**Invitation to Bid –
Lisle Library District Nature Trail**

Addendum No. 02

Date Issued: October 19, 2026

1 LANDSCAPE PLAN

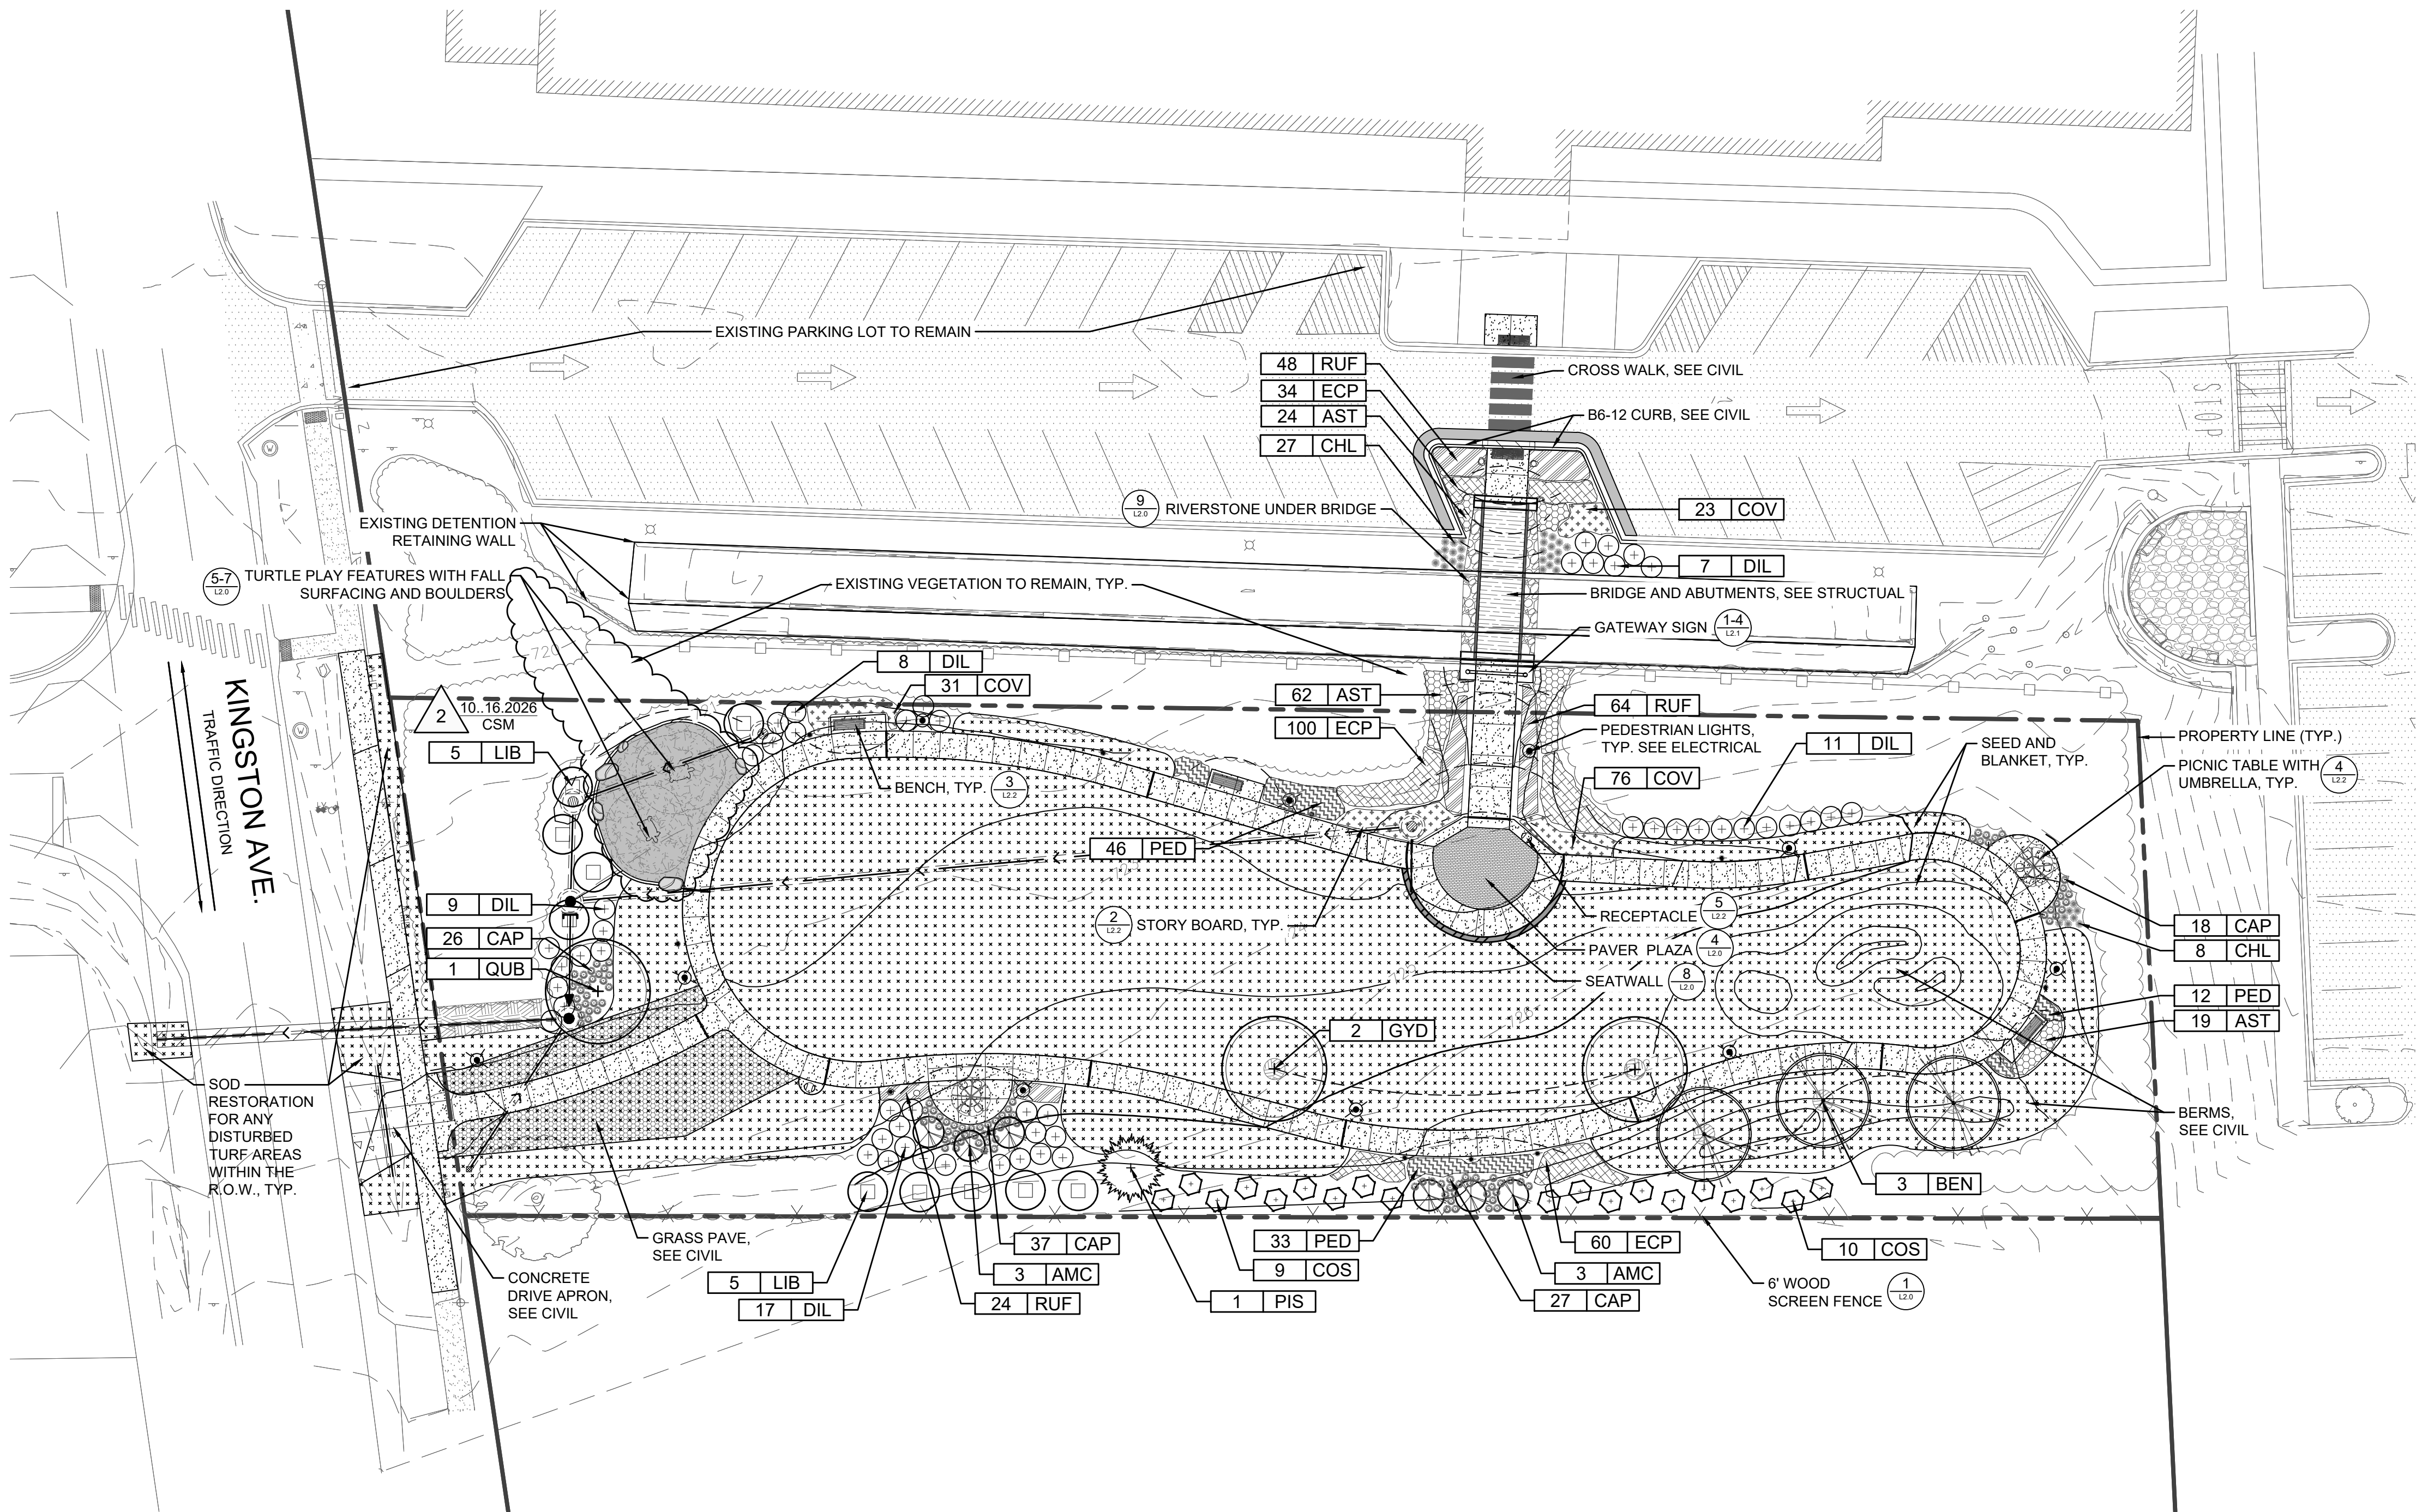
Question/Request for Information #19: Please confirm the quantity of tortoise play features for the Lisle Library District Nature Trail.

Response/Clarification #19: Two tortoise play features are proposed. See revised sheet L1.0, attached.
